Our Ref: KP1/9A.3/OT/23/20-21/JN/jk

21st January 2021

RE: ADDENDUM NO. 3 TO TENDER NO.KP1/9A.3/OT/23/20-21 FOR SUPPLY OF SMART LARGE POWER METERING UNITS

4. OUTDOOR METERING UNIT 11 KV50/1

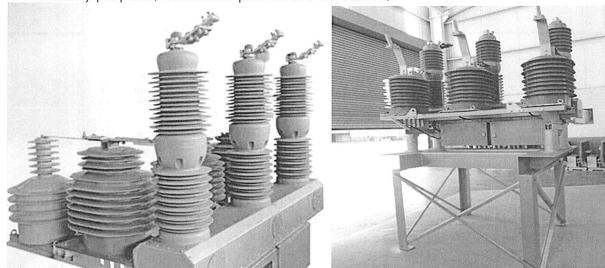
For clarity purpose, the below photos are attached;
